Staff Report

Item: PS22-0003: Roberson Pines Subdivision Preliminary Plat - Public Hearing

Figure 3 - Preliminary Plat

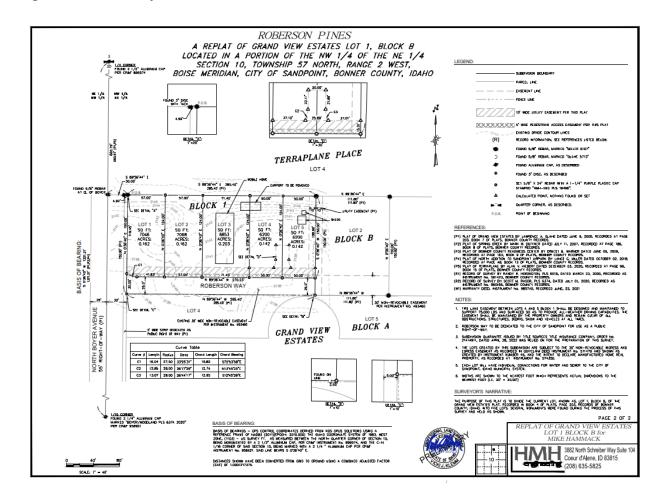
The existing access (Roberson Way) to the eastern lots is located on the subject property and is provided by a 30' easement recorded in 1996. The existing condition of the access is similar to a shared driveway, except it is not constructed in accordance with City standards that are intended to ensure safe and maintainable access for property owners, as well as emergency services, mail delivery services, etc. City Code does not permit private streets, primarily because enforcement of law on private property is limited. For example, law enforcement may not cite a vehicle for blocking access on a private street and the City has no authority to require it be maintained in the winter to provide access in the event of a fire. As a result, dedication of public right-of-way is in the public and property owner's best interest, as reflected on the preliminary plat.

The proposed paved width meets fire code. A full 60' wide right-of-way is not viable as it would result unbuildable lots due to the dimensions of the existing lot and the location of the existing single-family dwelling. Absent the full 60' width, snow storage and pedestrian access on private property by way of an easement is required. While the reduced right-of-way width is not ideal, the new public access substantially improves the existing non-conforming conditions, specifically, enabling legal and safe access. See the proposed conditions related to a road maintenance agreement, signage (no parking), and fire apparatus easement/turn-around.

- 6. Amend the right-of-way dedication note to omit "City" and to add "privately maintained."
- 7. Omit the note/leader referencing the easement along the section that is publicly dedicated.
